ADDENDUM NO. 1

Reference: Fillmore Armory Upgrade
Utah National Guard – Fillmore, Utah
DFCM Project No. 09242470

ADDENDUM # 1

PROJECT: Utah National Guard
Fillmore Armory Upgrades
Project No. - 09242470
36 W Center Street
Fillmore, UT 84631

C5
A503

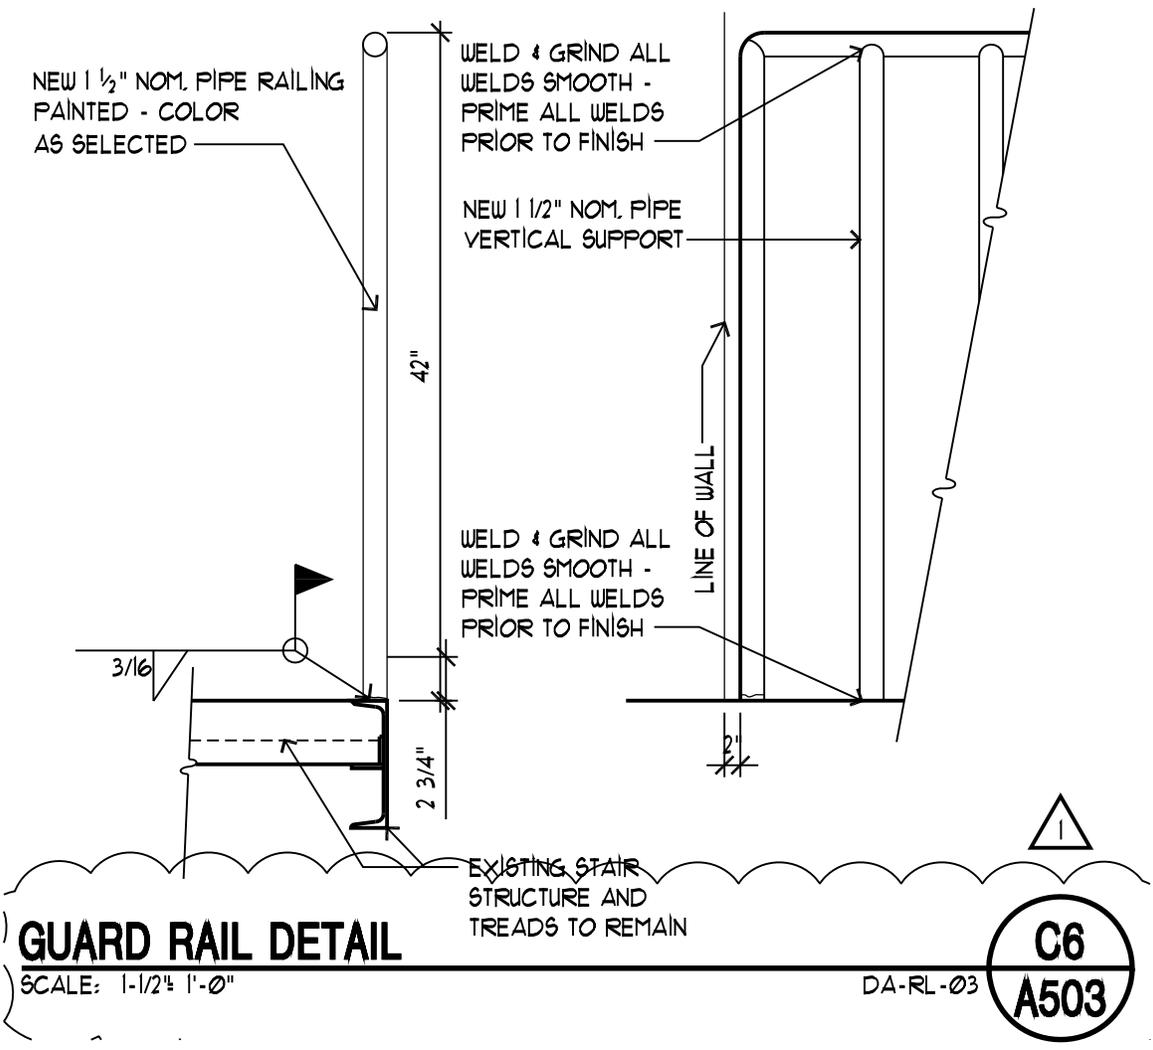
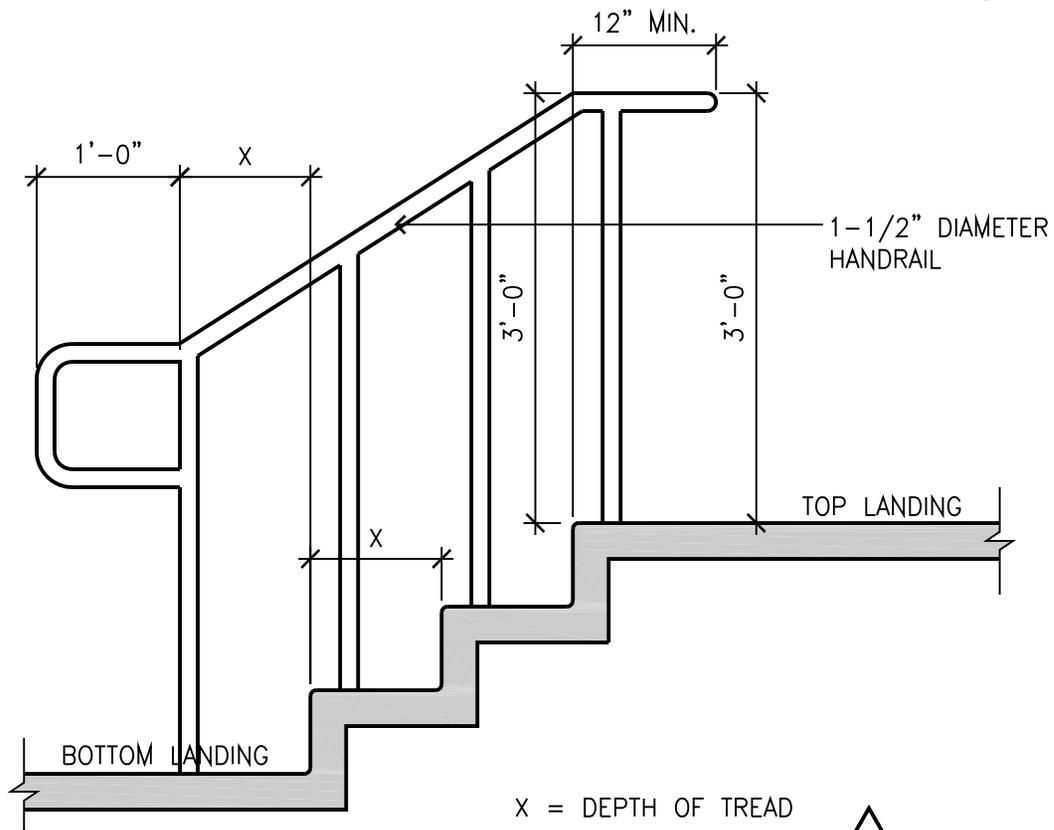
- 25.2. Detail C5 added- see attached detail.
- 25.3. Detail C6 added- see attached detail.
26. SHEET A-601 DOOR & WINDOW SCHEDULE:
- 26.1. Frame Type F5- The material should be changed from Hollow-Metal to Aluminum as per specification 084113.
